Subject Comments on Solar Millennium Blythe Solar Power Project

## **Comments of Greenaction for Health and Environmental Justice On Draft Environmental Impact Reports for the Genesis Solar Energy Project, Blythe Solar Power Project, and Palen Solar Power Project**

Notice of Availability of the Draft Environmental  
Impact Statement and Revised Staff Assessment for the Chevron Energy Solutions/Solar  
Millennium, Blythe Solar Power Project and Possible California Desert Conservation  
Area Plan Amendment, CEC Docket No. 09-AFC-6, BLM Docket No. CACA 48811

**Re: Comments on the Draft Environmental Impact Statement/Staff Assessment for the Chevron Energy Solutions/Solar Millennium (CESSM) Blythe Solar Power Plant (BSPP) and Possible California Desert Conservation Area Plan Amendment (Federal Register, 4/6/10 Notices, Vol. 75, No. 65: 17431)**

**Exhibit 1: Conceptual Gen-tie Diagram**

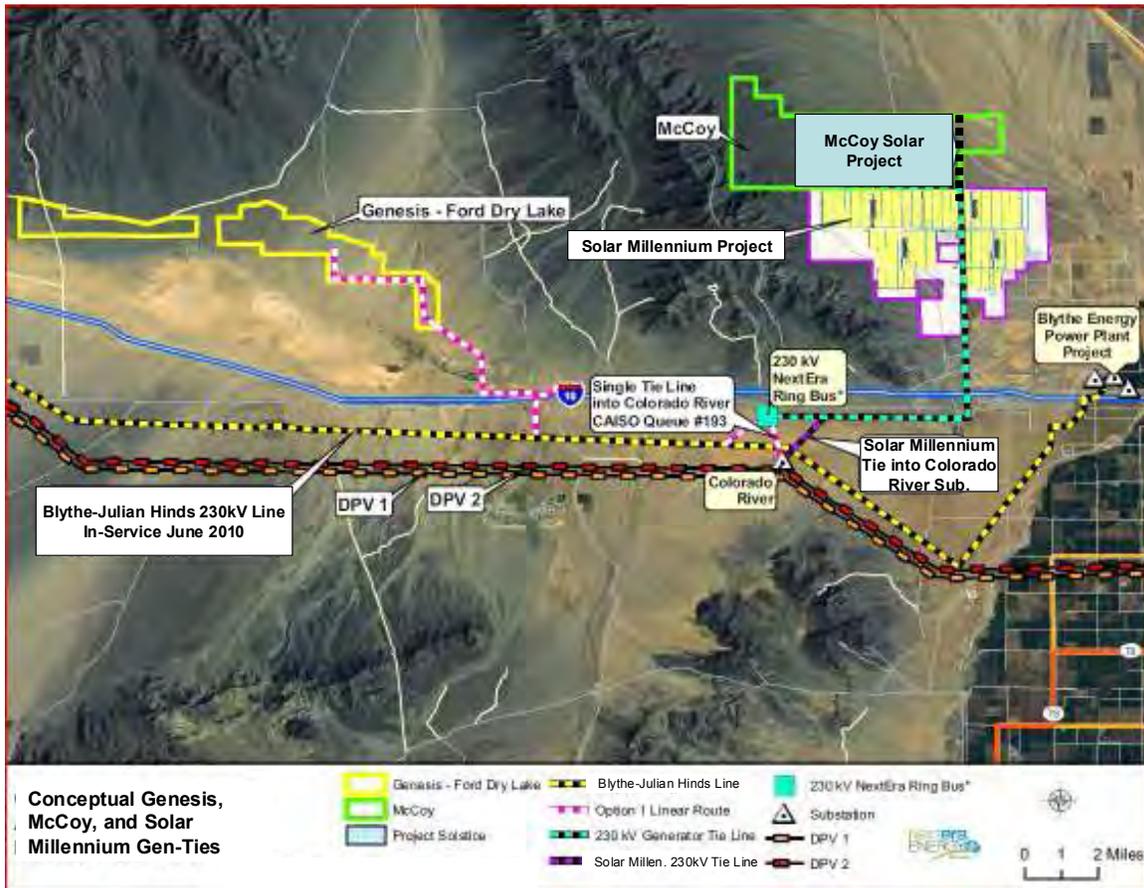
This Utility Corridor and additional double circuit 230kV line would allow projects to the north of the Solar Millennium Project to access Colorado River Substation with less environmental and land use impacts than alternatives which would involve creating additional, separate transmission line corridors around Solar Millennium’s Project either to the west or to the east. NextEra would also provide a similar transmission right-of-way access along the eastern boundary of McCoy as shown in Exhibit 1, attached. By establishing the Utility Corridor, linear facilities from projects to the north would be combined and minimized, consistent with BLM and CEC best practices guidance for desert renewable energy projects.
